### Reasons To Deny Landmarks Commission Approval Of 7/10/17 Submission For 801 Williamson

1 Floor Heights 805 Williamson (811 similar)  
801b Scale: 1/8" = 1'-0"

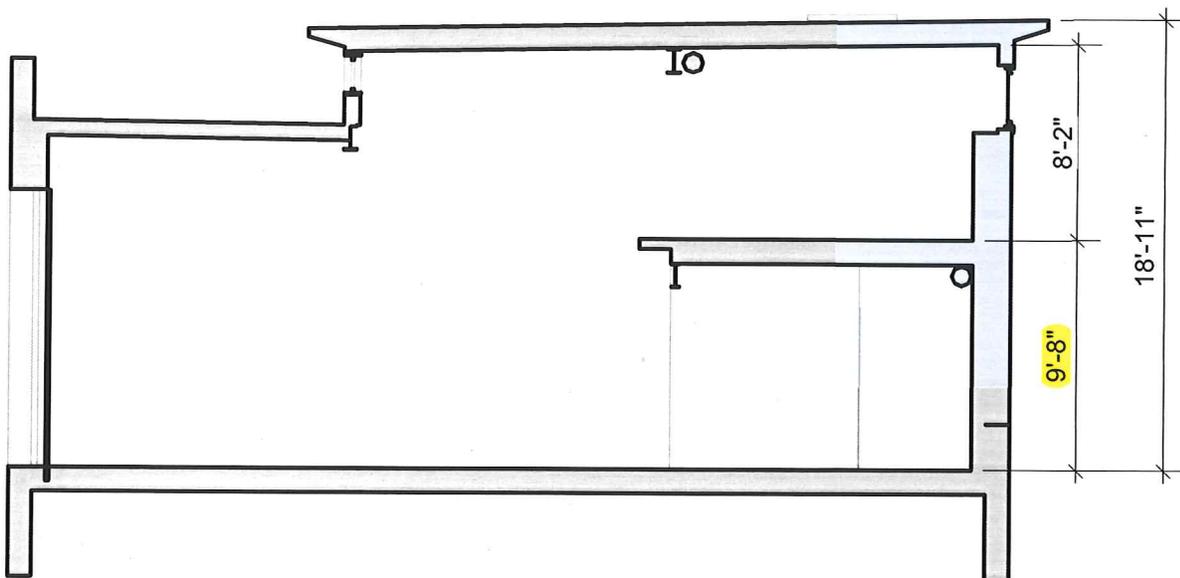
Floor-to-floor heights can be easily lowered to a more historical standard. Adjacent properties (805, 809) have commercial first floor heights of 9'-8" floor-to-floor. Second floor residential ceiling heights is 7'-4" (805, 811). **A minimum of 1'-0" should be removed from each or the floors, reducing 801 building height from 33'-4½" to 30'-4½", still over 4 feet higher than the next two streetfront buildings.**

1 Submission Page 5  
801c

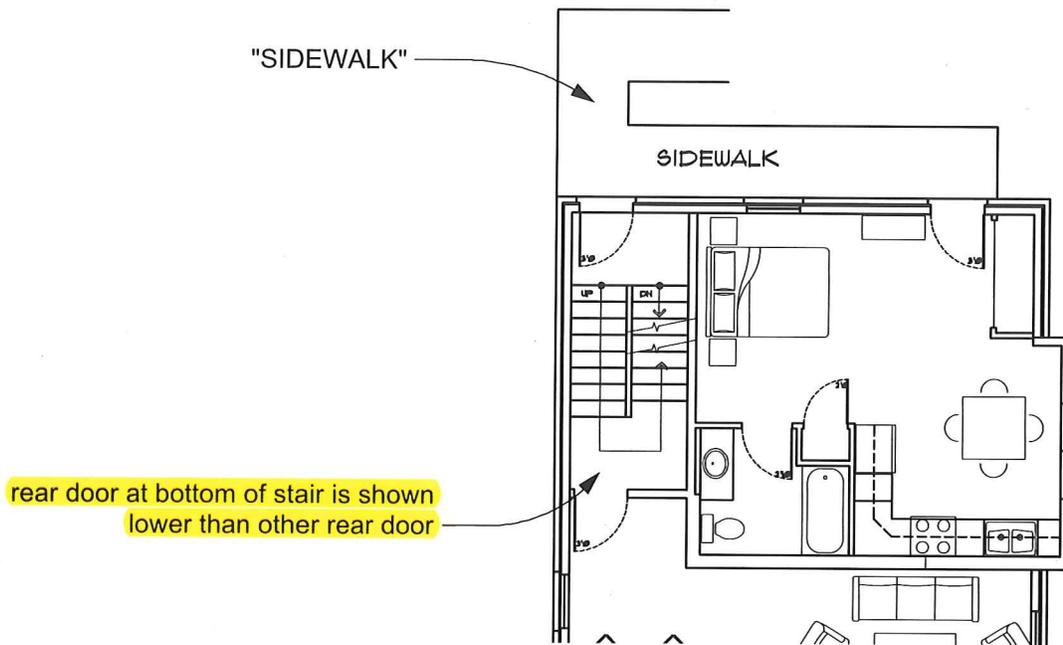
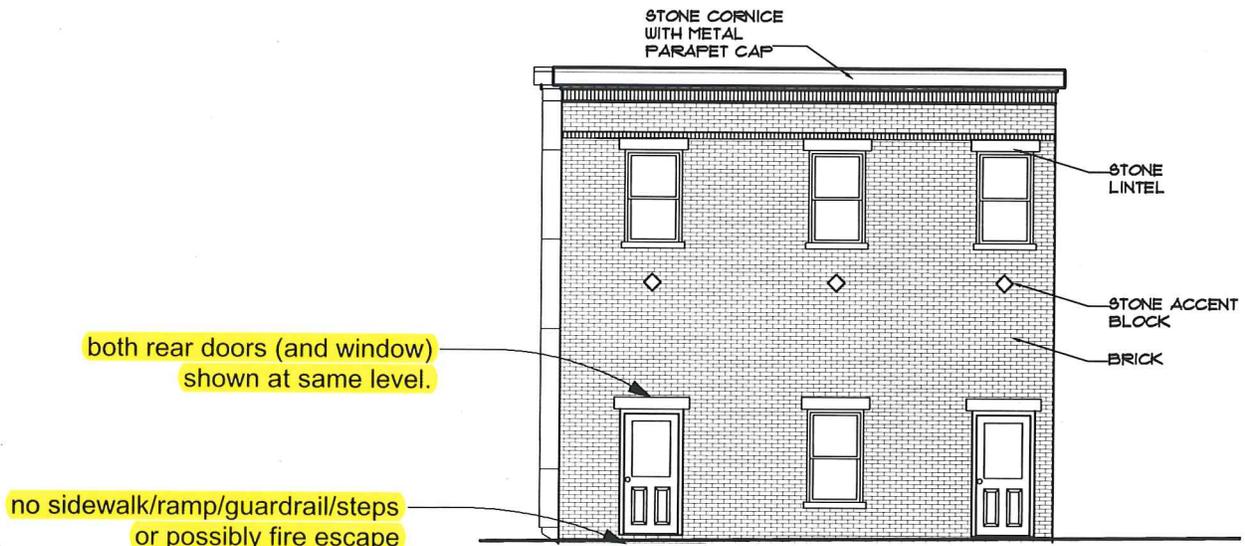
Plans submitted are contradictory, incomplete, and lack critical exterior dimensions. The fifth page shows a "sidewalk" that may in actuality be a ramp or stair with guardrails or a fire escape, and two doors appear to be at different levels. The fourth page does not show the "sidewalk"/ramp and shows the two doors at the same level. **A significant architectural element, the rear sidewalk/ramp/guardrail/fire exit is not shown clearly in any of the drawings.**
